UNITED STATES PATENT AND TRADEMARK OFFICE

APPLICATION NO.	FILING DATE	FIRST NAMED INVENTOR	ATTORNEY DOCKET NO.	CONFIRMATION NO.
10/696,932	10/30/2003	James F. McGuckin JR.	1255	1044
7590 NEIL D. GERSHON REX MEDICAL 1011 HIGH RIDGE RD Stamford, CT 06905				
EXAMINER SHAFFER, RICHARD R				
ART UNIT		PAPER NUMBER		
3733				
MAIL DATE		DELIVERY MODE		
09/30/2008		PAPER

Office Action Summary

DETAILED ACTION

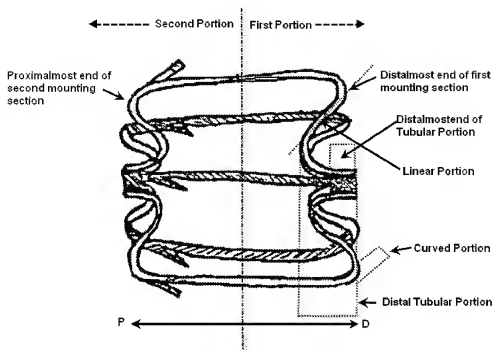
Bosma et al disclose all of the claimed limitations except for the specific structure and location of the filtering section with regard to the mounting section. Van der Burg et al teach (**Figure 35; Column 18, Lines 34-55**) that an expandable device for placement against a bodily tubular structure with an S-shape end portion provides an elongated mounting section which improves contact area. It would have been obvious to one having ordinary skill in the art at the time of invention to design the filter of Bosma et al according to the structure taught in Van der Burg et al in order to improve fixation within the blood vessel. In regard to applicant's extensive claim language defining the relationship between the filter section and mounting section, see the Figure below depicting how the structure of Van der Burg et al meets the claimed limitations.

Applicant states that Van der Burg et al lack a distalmost end point of a distal tubular portion proximal of distalmost end points of struts of the mounting section. As shown in the figure in the previous page, at least the two bottom struts on the right are shown distal of the distalmost point of the tubular section as well as the two back struts on the left side being proximal of the proximalmost point of the tubular section.

Applicant additionally contends that Van der Burg et al lack linear portions of the mounting sections extending axially and radially inward. Again, as previously shown, there are portions that depict a linear strut member.

Applicant also states that Van der Burg et al lack the proximalmost and distalmost end points of the tubular portions axially aligned with a region of the linear portion. As already described in this remarks, there are portions further from the center of the device including a portion of the linear portion therefore axially aligning the distalmost/proximal most tubular end points with the linear portions of the struts.
